Bulletin No.: 14888D  
Date: June 2015

# Recall Bulletin

**SUBJECT:** Front-Brake Caliper Leak

**MODELS:** 2015 Chevrolet Colorado  
2015 GMC Canyon

**Front Caliper Body Casting: Outboard Body**

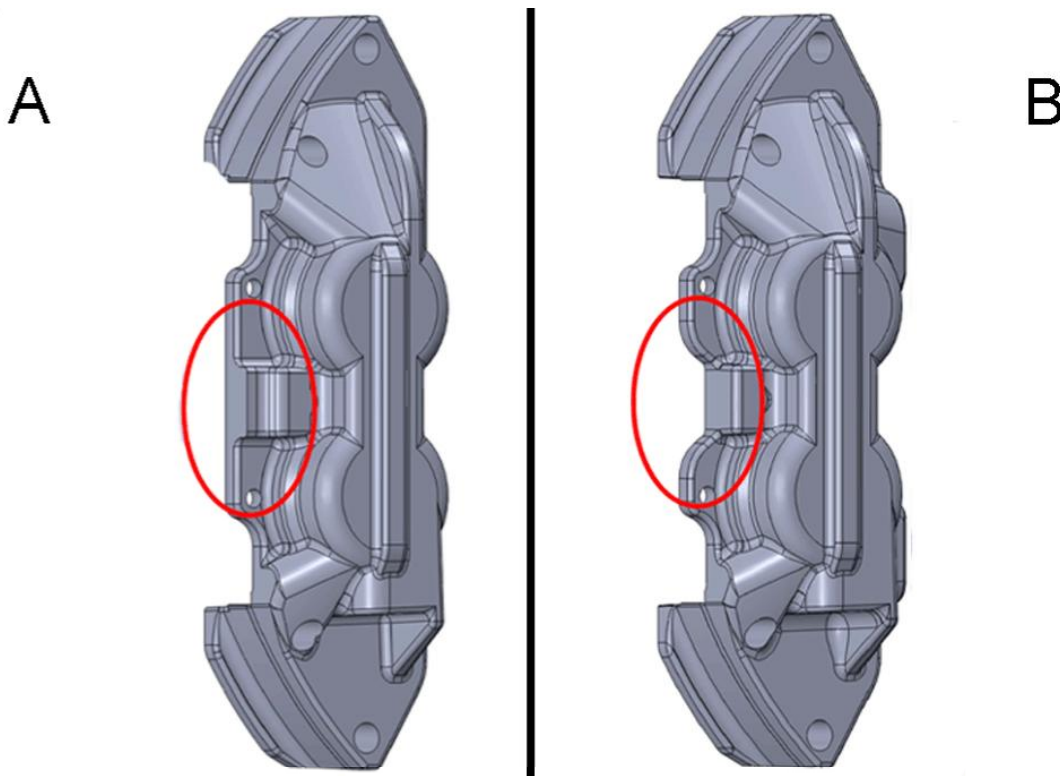
**(A) Original Design Front Caliper Body Casting (B) New Design Front Caliper Body Casting.** The shape of the pin ledge is different between the two designs. Refer to the area in the circles of the illustration to review the differences in the shape of the pin ledge from the original design to the new design.

3. Perform a visual inspection of the front calipers to determine the body casting design of the caliper.
    - If the vehicle is equipped with the original design front caliper body casting, remove and replace both front calipers. Proceed to step 4.
    - If the vehicle is equipped with the new design front caliper body casting, no further action is required. Install the tire and wheel assembly and lower the vehicle. Refer to *Tire and Wheel Removal and Installation* and *Lifting and Jacking the Vehicle* in SI.
  4. Remove the front brake calipers from the vehicle. Refer to *Front Brake Caliper Replacement* in SI.
- Note:** Transfer the brake pads from the old calipers to the new calipers BEFORE discarding the brake calipers.
5. Discard the front brake calipers.
  6. Install new front brake calipers to the vehicle. Refer to *Front Brake Caliper Replacement* in SI.
